RE: 4002 12th St NW

Grading and Drainage Plan Engineer's Stamp Date: 9/5/2023 Hydrology File: G14D102

Based upon the information provided in your submittal received 9/7/2023, the Grading & Drainage Plan is approved for Grading Permit and Building Permit approval. Please attach a copy of this approved plan in the construction sets for Building Permit processing along with a copy of this letter.

GD-1

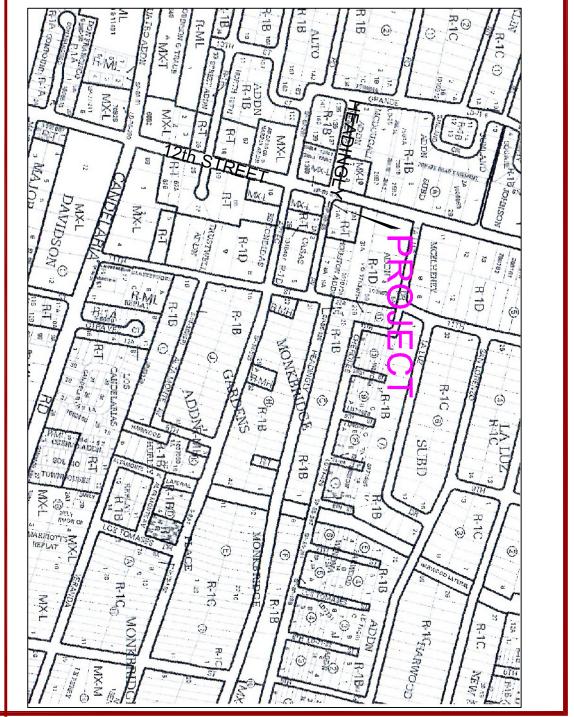
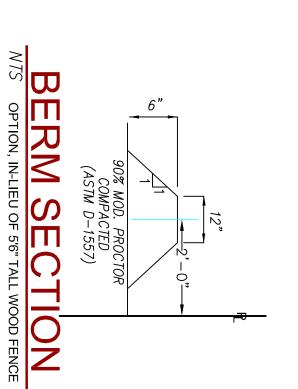
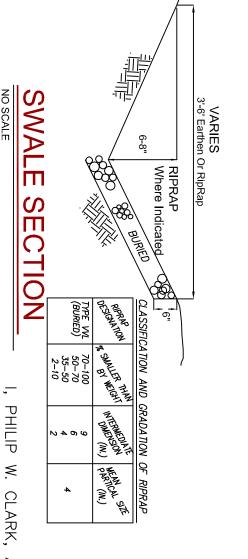
1. Engineer's Certification, per the DPM Part 6-14 (F): *Engineer's Certification Checklist For Non-Subdivision* is required.

2. Please provide the executed paper Drainage Covenant (latest revision) printed on one-side only with Exhibit A and a check for \$25 made out to "Bernalillo County" for the stormwater quality ponds per Article 6-15(C) of the DPM to Hydrology for review. Once the review is done, Hydrology will send back an email stating our approval/comments.
